# Engagement Outcomes Report and Response to Comments

## Naremburn Local Centre Streetscape Upgrade Concept Designs

February 2023

## Naremburn Local Centre Streetscape Upgrade

**Design Concept Option 1**  
Preliminary Concepts  
Merimburn Town Centre Upgrades

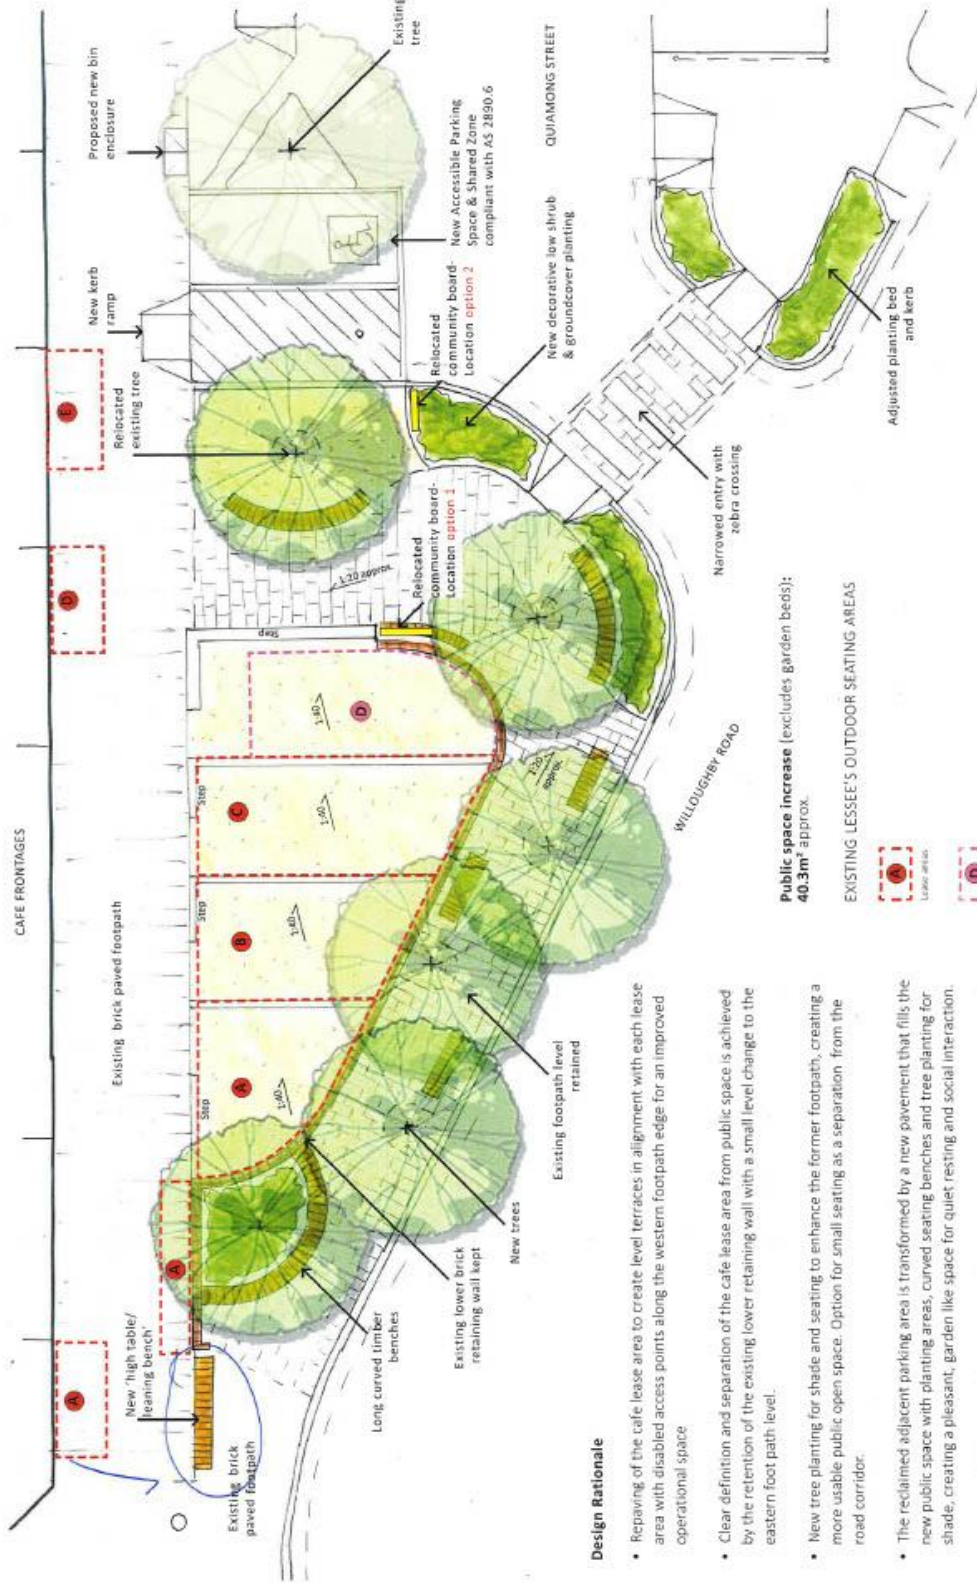
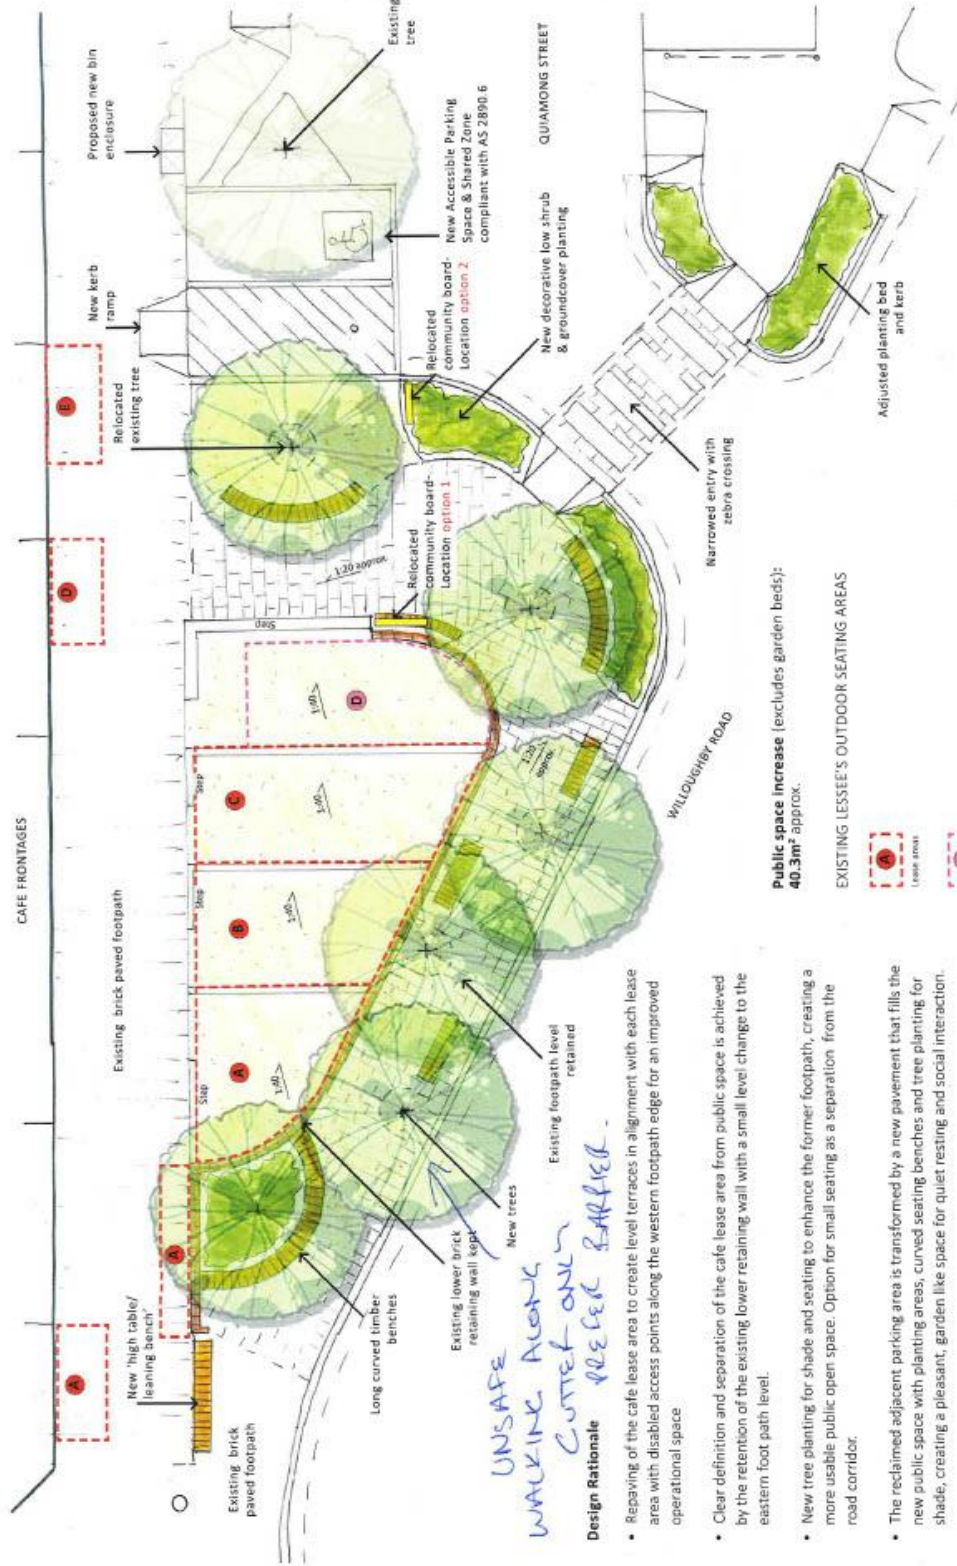
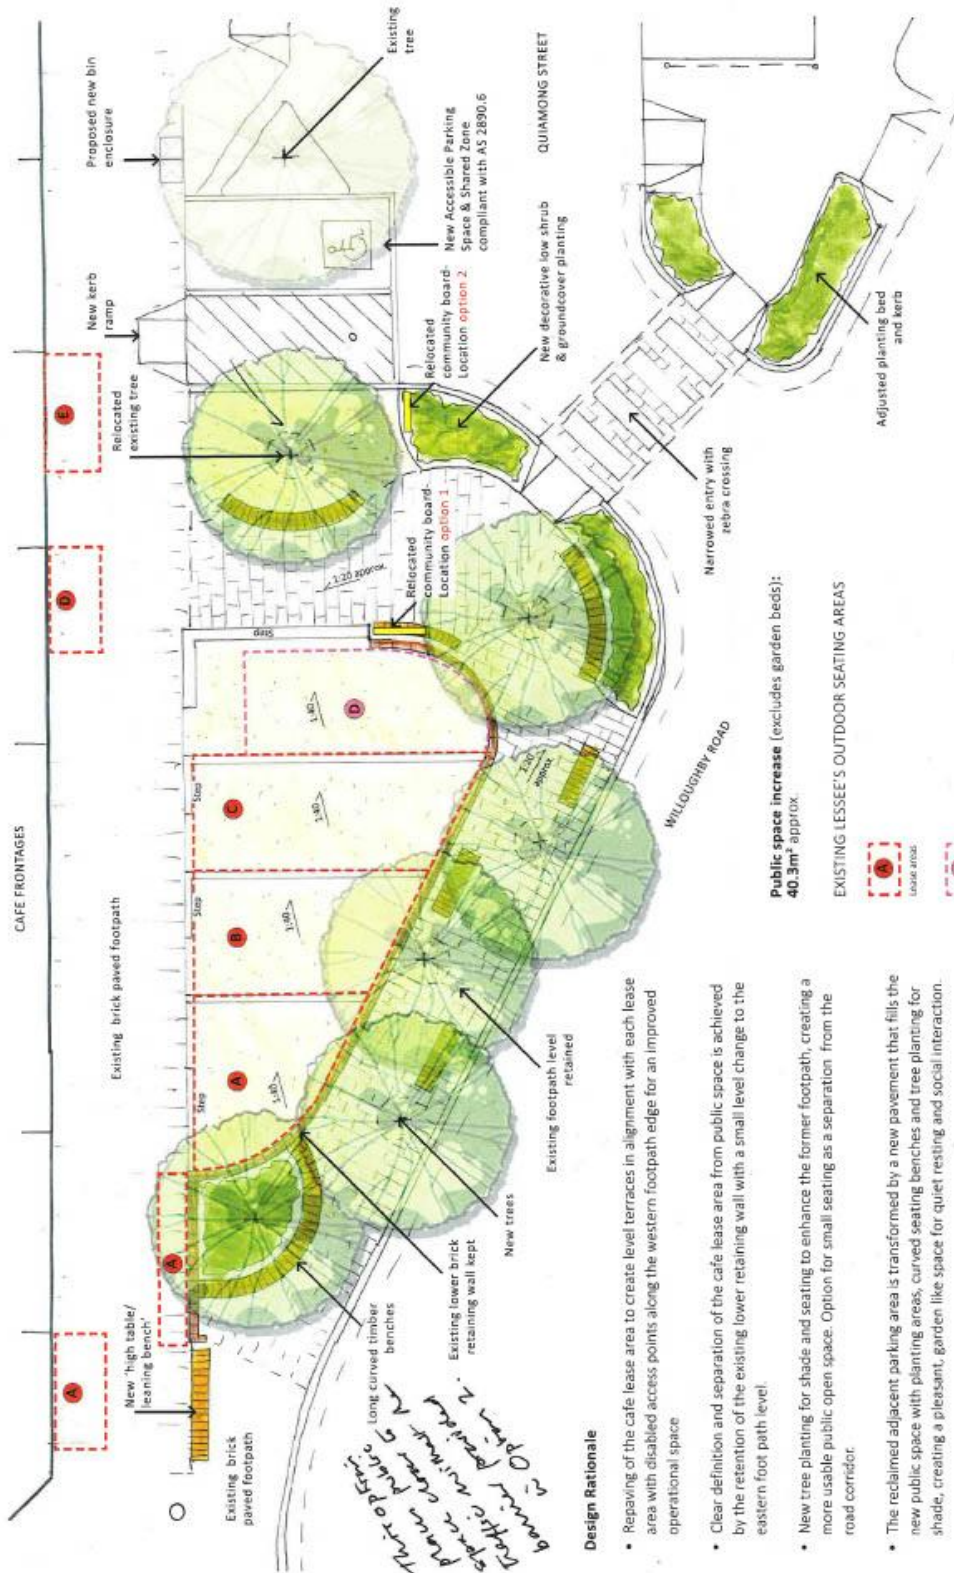
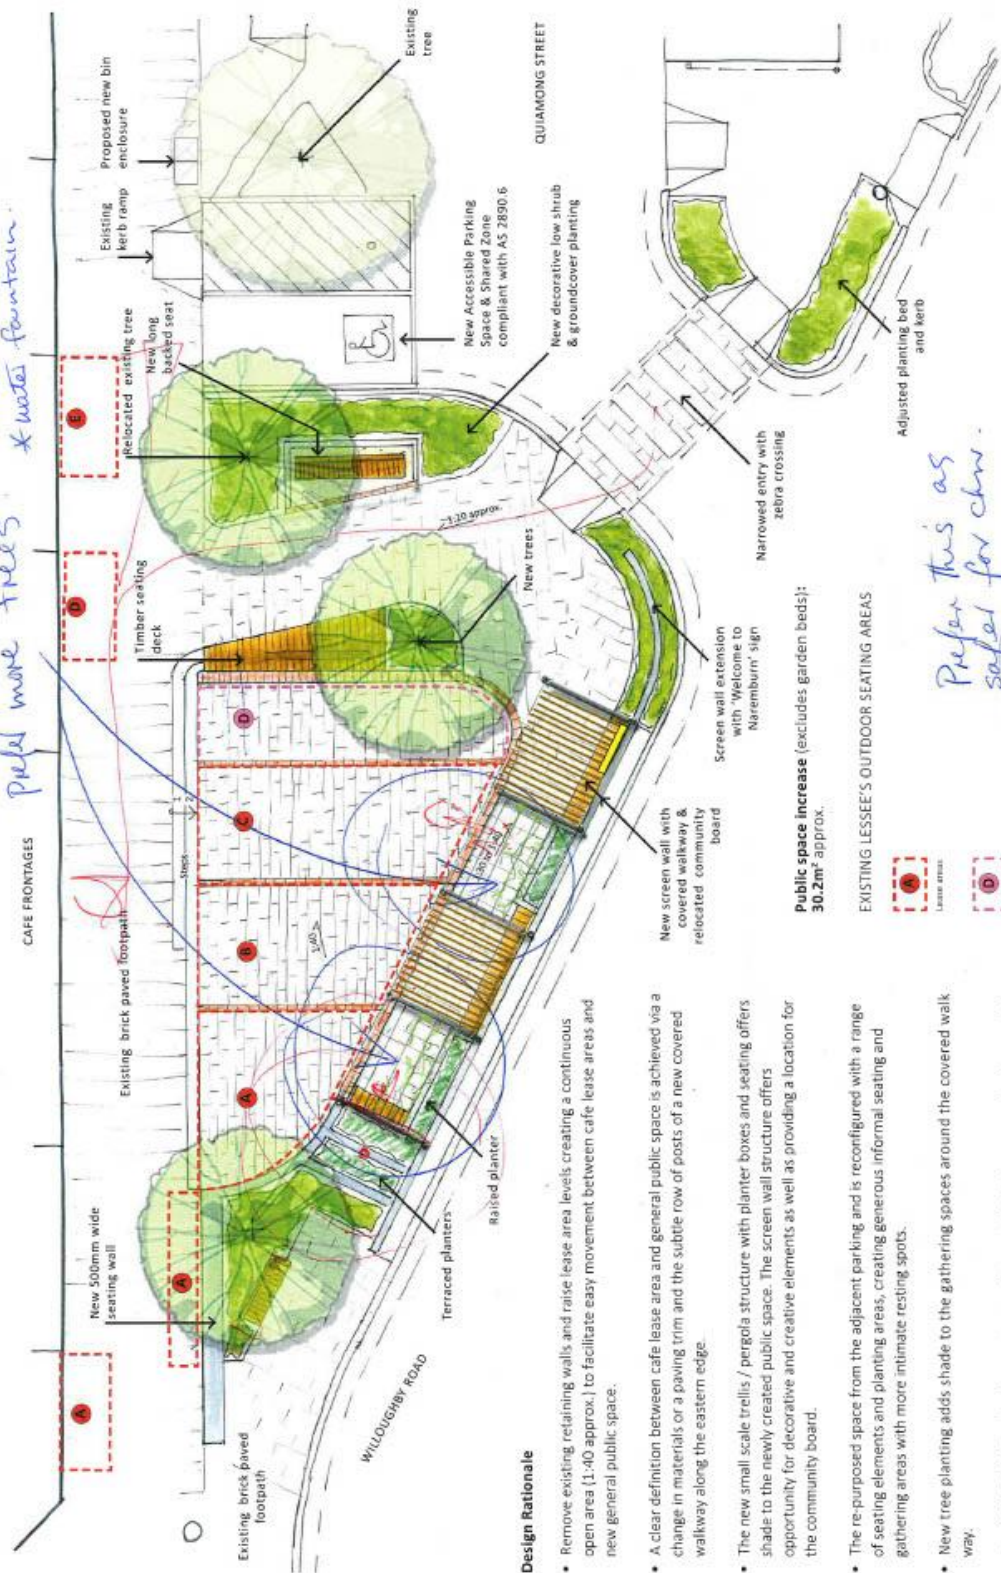
*coffee plants to plant on fence throughout as a hedge*

include planting to mitigate movement of the road

**Proposed Parking & Vehicle Circulation Plan**

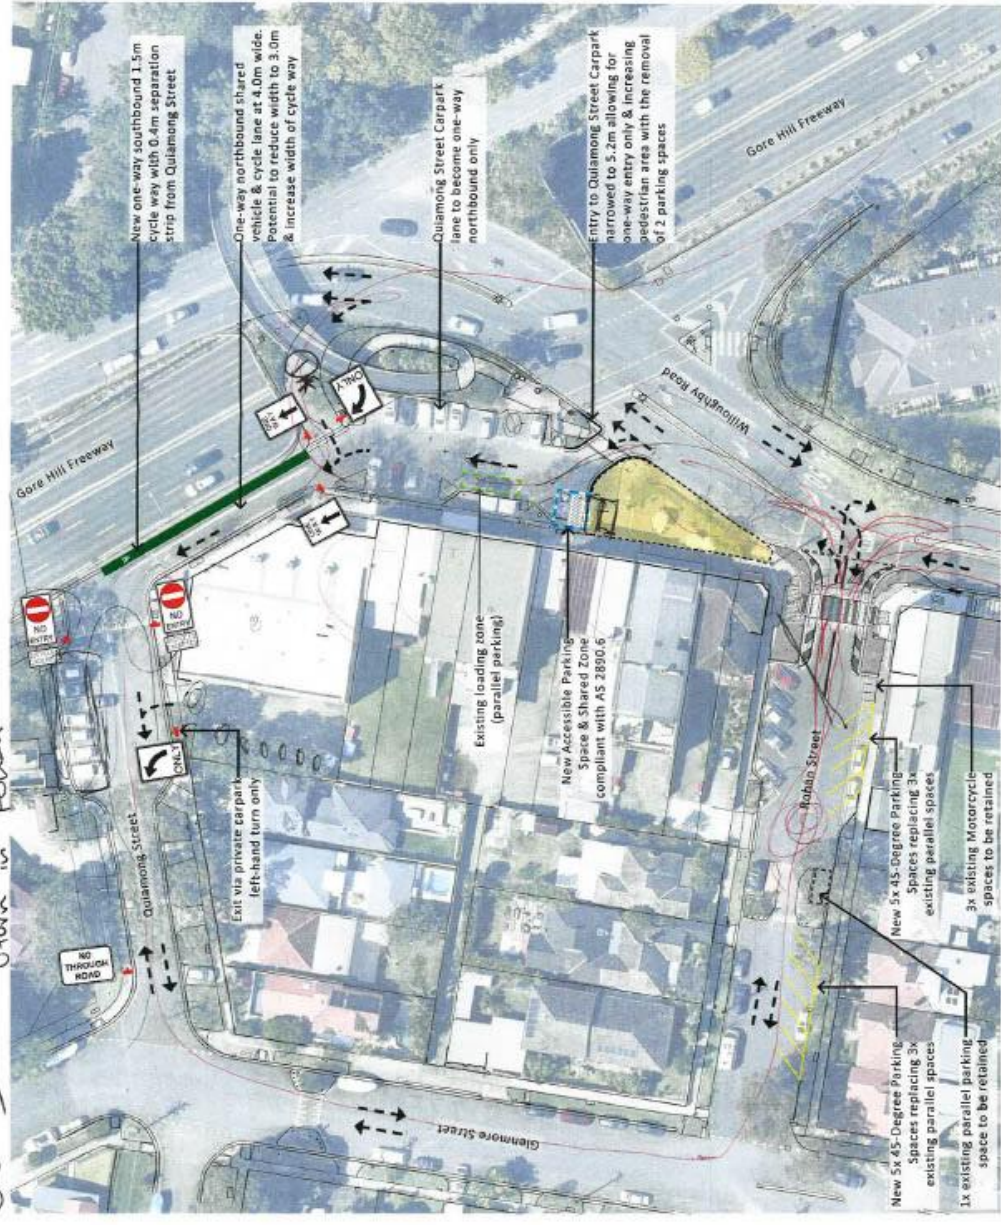
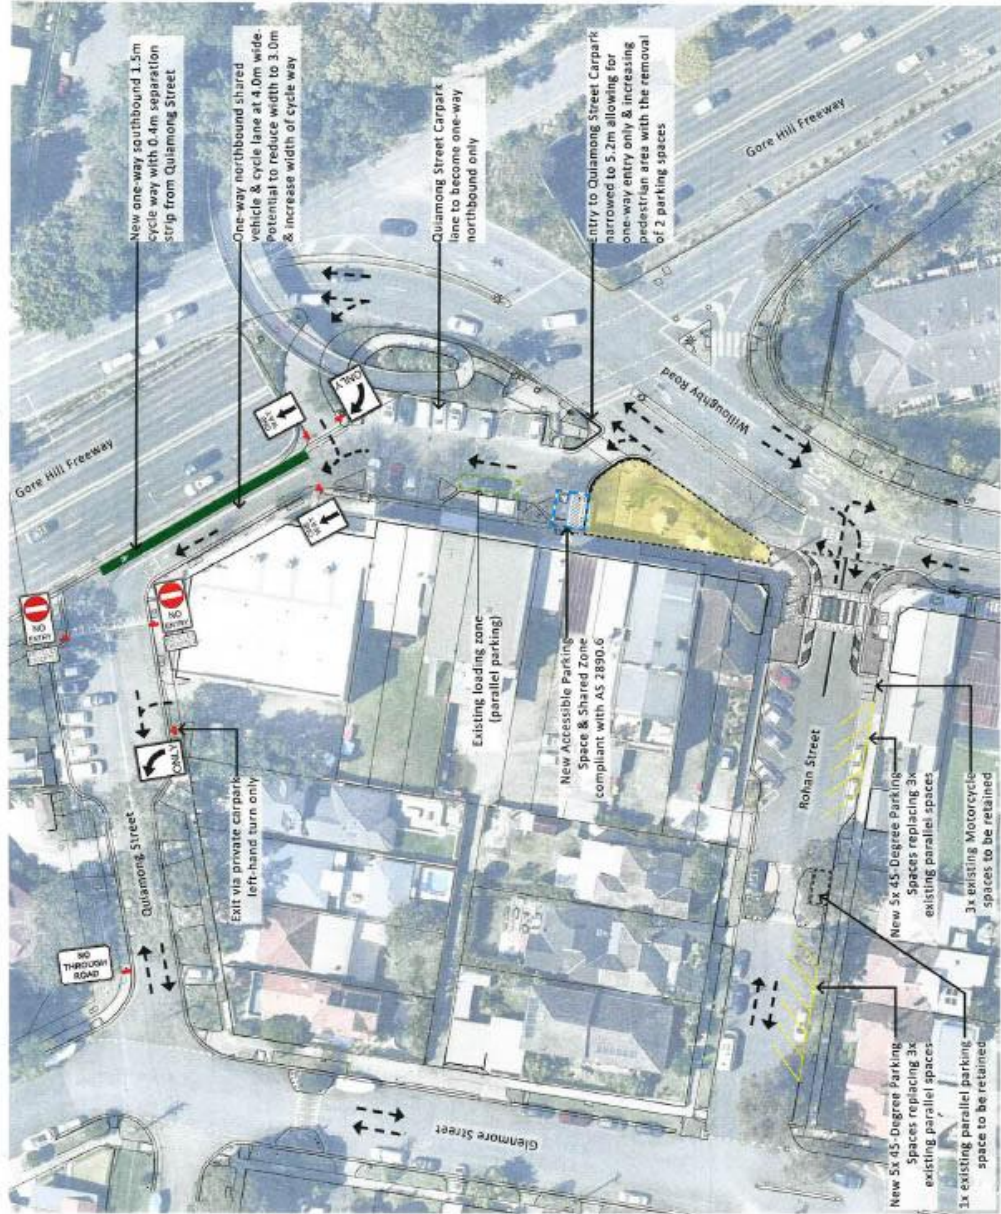
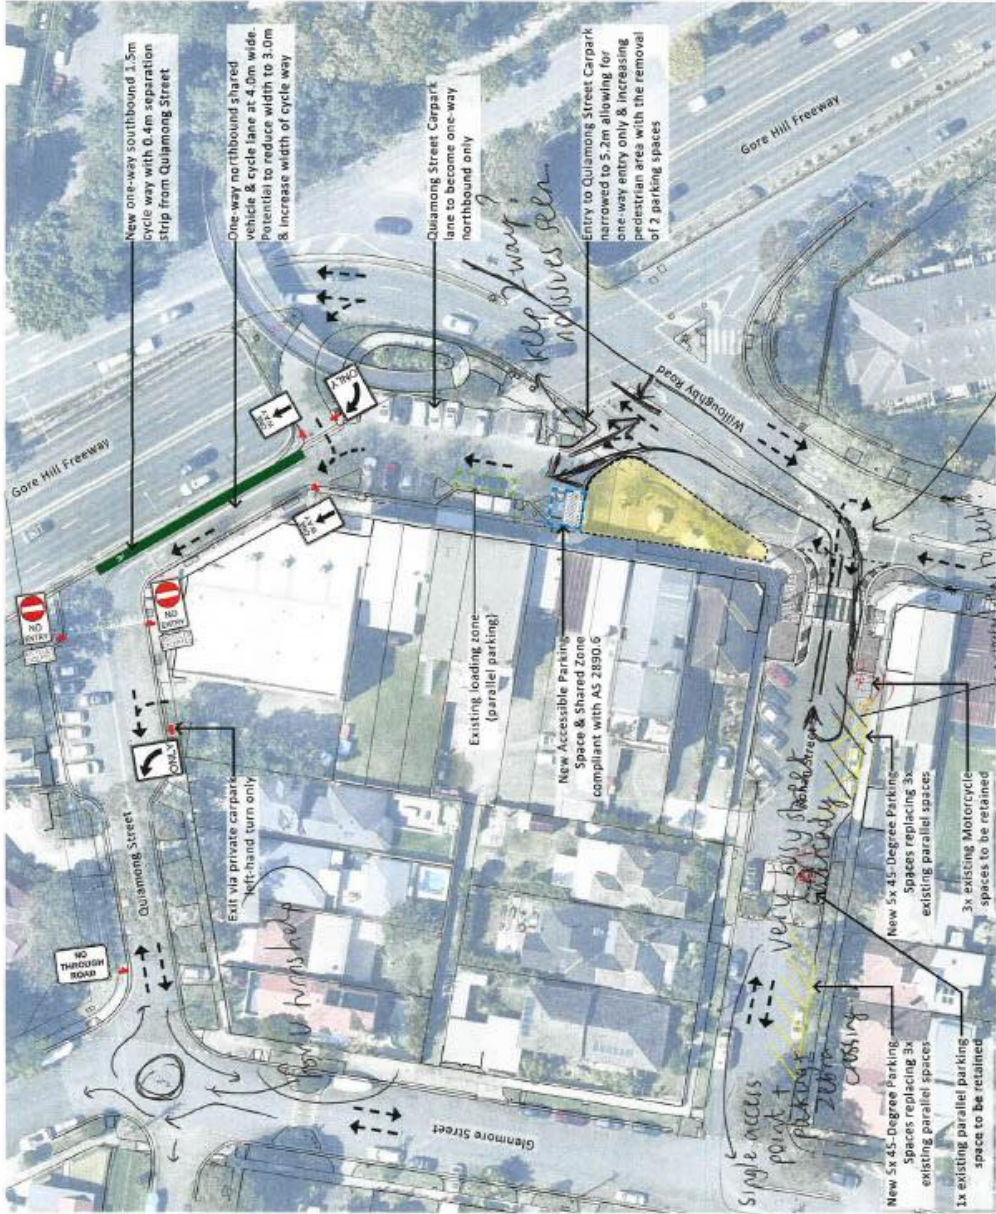
Agree i flow of traffic in this plan.
